HARLEY-DAVIDSON

**SERVICE BULLETIN**

M-754A

**REAR BRAKE MASTER CYLINDER PISTON / 1979 MODELS**

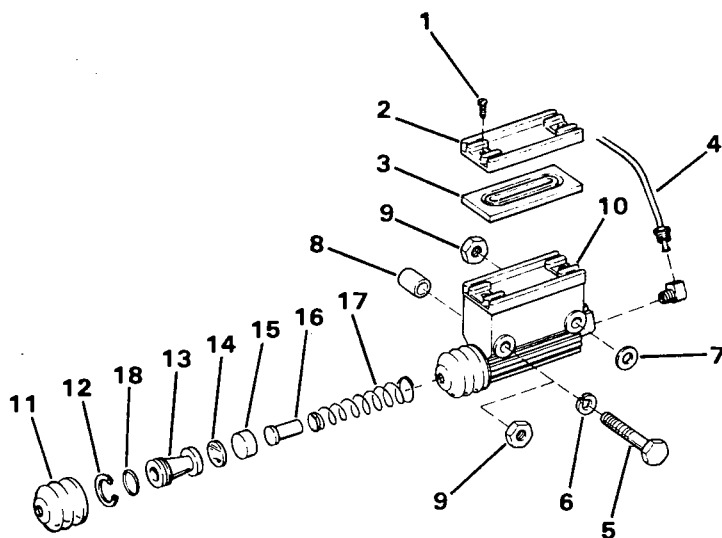
A quantity of 1979 model 1200/1340 and 1000cc motorcycles were assembled and shipped with master cylinder pistons made from an incorrect material as received from our supplier.

The incorrect material may allow water absorption to a greater degree than the correct material specified by Harley-Davidson. A plastic piston made of this incorrect material, in isolated instances, might stick in the master cylinder piston bore. This condition would most likely come on gradually as the piston absorbs moisture and swells. If this sticking occurs, the brake may not fully release and will have a tendency to drag. If the motorcycle operator does not heed this prior warning, it is possible, though extremely unlikely, that this condition may become severe enough to make the rear wheel skid, or a dragging brake may generate enough heat to make the brake fluid boil causing an ineffective brake. Either of these conditions could cause the motorcycle operator to lose control.

1. Cover screw
2. Cover
3. Gasket
4. Brake line
5. Bolt (1 FL, 2 XL and FX)
6. Lockwasher (2 FX, 2 XL)
7. Washer (1 FL)
8. Spacer (2 FX)
9. Nut (2 FL)
10. Master cylinder
- \*11. Rubber boot
- \*12. Retaining ring
- \*13. Piston assembly
- \*14. Valve wafer
- \*15. Piston cup
- \*16. Spring stop
- \*17. Spring
- \*18. O-Ring

\*Parts supplied in master cylinder piston kit.

**XL Models:** Remove master cylinder cover screw (1), cover (2) and gasket (3). Disconnect brake line (4) at master cylinder. Remove bolts (5), lockwashers (6) and remove master cylinder (10) from motorcycle allowing brake operating linkage to remain connected.

**FL Models:** Loosen master cylinder mounting bolt (5) and nuts (9) enough to remove chrome cover (not shown). Remove master cylinder cover screw (1) cover (2) and gasket (3). Disconnect brake line (4) at master cylinder. Remove front bolt (5), washer (7) and nut (9), remove rear stud nut (9) and remove master cylinder (10) from motorcycle.

**FX Models:** Remove exhaust pipes and muffler. Remove master cylinder cover screw (1), cover (2) and gasket (3). Disconnect brake line (4) at master cylinder. Remove bolts (5), lockwashers (6) and spacers (8), and remove master cylinder (10) and sidecover (not shown) from motorcycle.

**All Models:** Remove rubber boot (11), retaining ring (12), piston assembly (13), wafer (14), piston cup (15), spring stop (16) and spring (17).

Reassemble master cylinder using new parts from kit (marked with asterisk \* in illustration). Dip all parts in new DOT 5 brake fluid and assemble in order shown with O-ring installed in groove on piston.
